CITY OF CODY
PLANNING, ZONING AND ADJUSTMENT BOARD
TUESDAY, MAY 8, 2018
CITY HALL COUNCIL CHAMBERS @ 12:00 NOON

**CITY OF CODY
PLANNING, ZONING AND ADJUSTMENT BOARD
STAFF REPORT**

MEETING DATE:	MAY 8, 2018 (CONTINUED FROM APRIL 24, 2018)	TYPE OF ACTION NEEDED	
AGENDA ITEM:		P&Z BOARD APPROVAL:	X
SUBJECT:	LANDSCAPE AND ARCHITECTURAL REVIEW: HIGH SCHOOL RESTROOM BUILDING EXPANSION AND TICKET BOOTH. SPR 2018-13	RECOMMENDATION TO COUNCIL:	
PREPARED BY:	TODD STOWELL, CITY PLANNER	DISCUSSION ONLY:

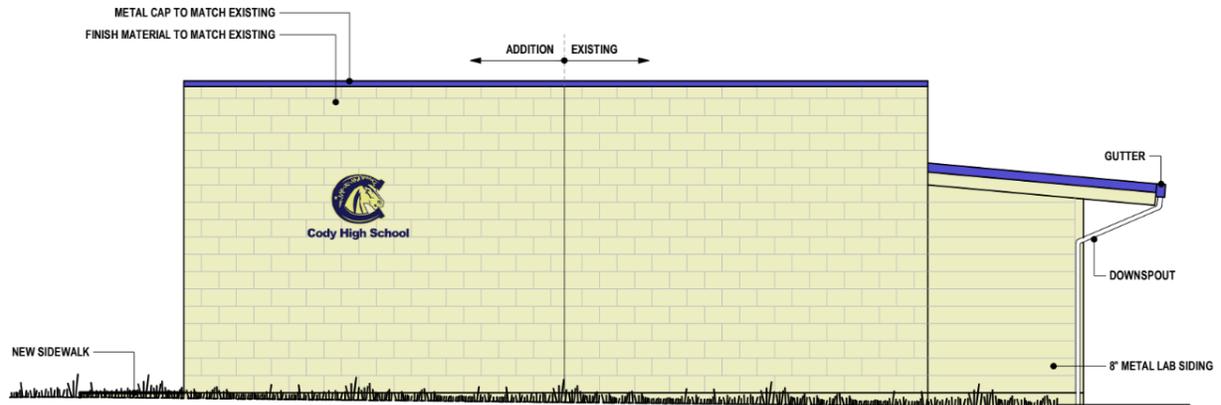
The architect and city staff were not previously aware that the school district has just completed a plan to re-do their exterior lighting at all of the district’s schools with LED lighting (almost all of which is dark-sky compliant). That project will occur this summer. The previously noted light fixture will not be used, but the following fixture, which is one of the fixtures they will be using on the larger lighting project. The complete specifications are attached. There will be four exterior lights—one on the west wall, one on the south wall and two on the east wall. The full cut-off nature of the fixture is appreciated and the lighting pattern will keep the illumination directed within the property.

The painting plan has been changed by adding a school logo to the north side of the building, changing the base color to “restrained gold” (think of the color on the school uniforms), and using a blue-colored metal wall cap.
